Open Space Services Formal Referral Response

Application Information	
Referral Officer	Nish Goonetilleke
Officer	Tree Dimensions (YH)
Council Reference	PPE23/0571
Address	300/658 Church St, Cremorne VIC 3121
Proposal	DEECA Referral
Comments Sought	Impacts upon existing street trees adjacent to the site (if relevant)

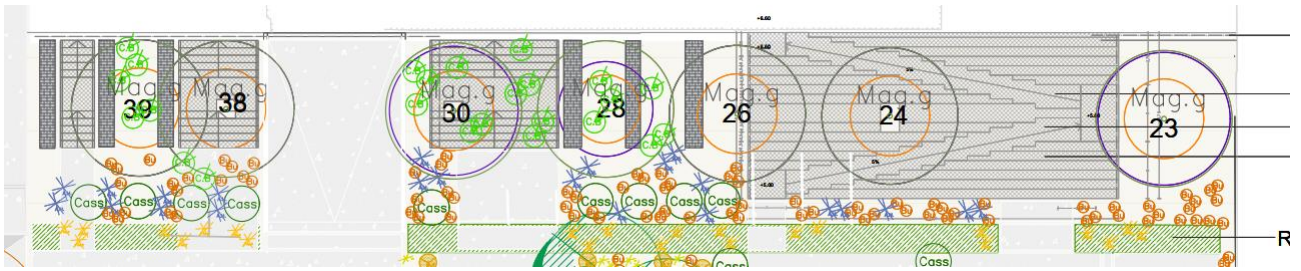
There is a lack of information about the proposed works. It is unclear whether the trees proposed to be retained will remain viable. For example, one of the proposed rain gardens which may involve excavation is within the SRZ of tree #5 (see snip from the landscape plan below)

1. Provide an Arboricultural Impact Assessment (AIA), including a clear photo of each tree, any design encroachments into the TPZ and SRZ of retained trees, and the impact on their health and longevity. Consideration of impact should include topography modification (cut and fill), proposed hard surfaces and any other landscape works. If required, additional investigation(s) (e.g. Non-destructive Root Investigation (NDRI)) and photographs of findings must be included.
